TENDER DESIGN

NOIDA METRO RAIL CORPORATION LTD.
Block-III, 3rd Floor, Ganga Shopping Complex, Sector-29, Noida -201301, District Gautam Budh Nagar, Uttar Pradesh, India

PROJECT: Contract NGNE-02: Design and Construction of Elevated Viaduct and 8 elevated stations from Botanical Garden to Noida Sector-142 of Noida-Greater Noida Metro Rail Project.

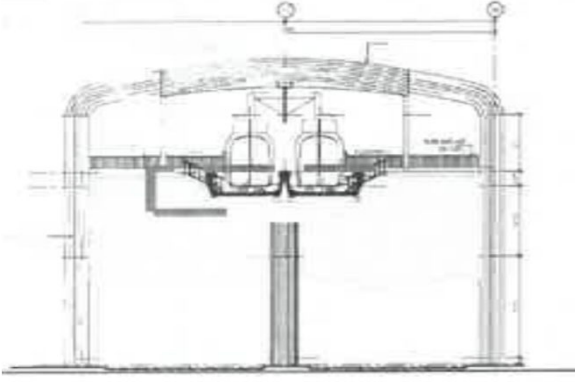
11	Volume-6 BOQ Page no 4	Schedule B			There is a typo error in the final total amount of the Bill of Quantities (BOQ) Scheduel B & C. The individual breakdown items do not add up to the stated final total. Please provide the corrected BOQ total.	Refer Addendum-1.
12	Volume-6 BOQ Page no 30	Schedule B	Item No. B2 8.9		There is a typo error in the Bill of Quantities (BOQ) Scheduel B2, Item No.8, Misc. Works. The individual breakdown items do not add up to the stated final total. Please provide the corrected BOQ total.	Refer Addendum-2.
13	Volume-6 BOQ Page no 33	Schedule B			There is a typo error in the total of the Bill of Quantities (BOQ), Total Schedule B2. Please provide the corrected BOQ total.	Refer Addendum-2.
					The tender text states that the scope includes the design and construction of the superstructure using standard U-girder spans and all other spans for the viaduct, including the station areas. However, the tender drawings show both U-girders and I-girders. The bidder requests to clarify which girder type is final and should be adopted for the pricing for station prtion.	The Station portion is in cast in-situ. However, the track in the non-concourse portion of the station is U-Girder. Further, refer Addendum-2.

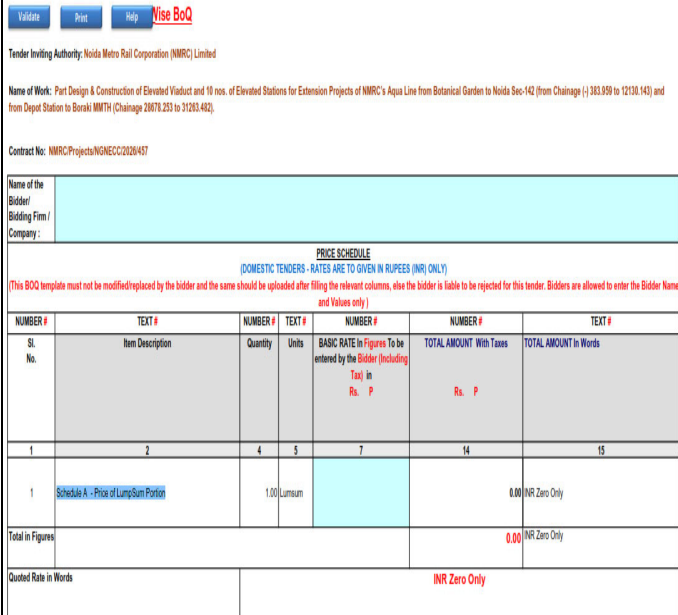
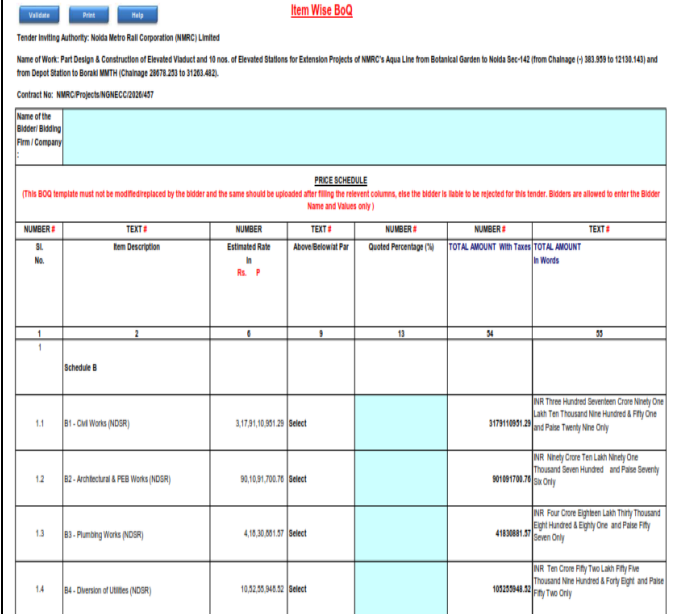
388				For Live load, two configuration was provided in outline design specifications	Kindly confirm the configuration to be adopted in structural analysis.	No change in Tender conditions.
